INFO-TECH CITROËN Racing C3R5 20-08

Sujet : Jauge à essence (904477528A)

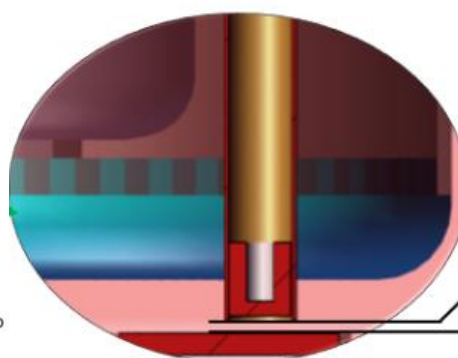
Afin d'éviter de blesser le fond de l'outre avec l'extrémité de la jauge, nous vous recommandons d'ajouter un point de colle (Araldite AW2101 - HW2951) à son extrémité.

Merci de garder un gap (mini) de 1mm entre l'extrémité de la jauge et l'outre. Vous pouvez ajuster ce gap via des joints cuivre (PS81052A10).

Minimum 1 copper washer for sealing. Add 1 or more washer to adjust the fuel gauge gap.

Gap = 1mm min

Nous vous conseillons ensuite de procéder à un nouvel étalonnage du réservoir suite à ce repositionnement de jauge.

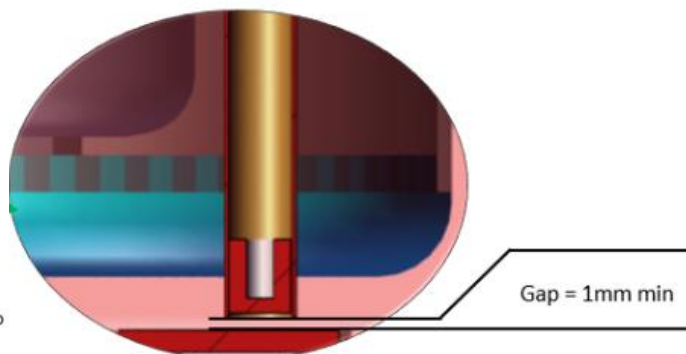
To avoid hurting the fuel cell with the extremity of the fuel gauge, we advise you to add some glue (Araldite AW2101 - HW2951) to the end of the gauge.

Please keep a gap of 1mm (min) between the fuel cell and the fuel gauge extremity by adjusting with copper washers (PS81052A10).

Minimum 1 copper washer for sealing. Add 1 or more washer to adjust the fuel gauge gap.

We recommend you to proceed a new fuel sampling following this gauge repositioning.
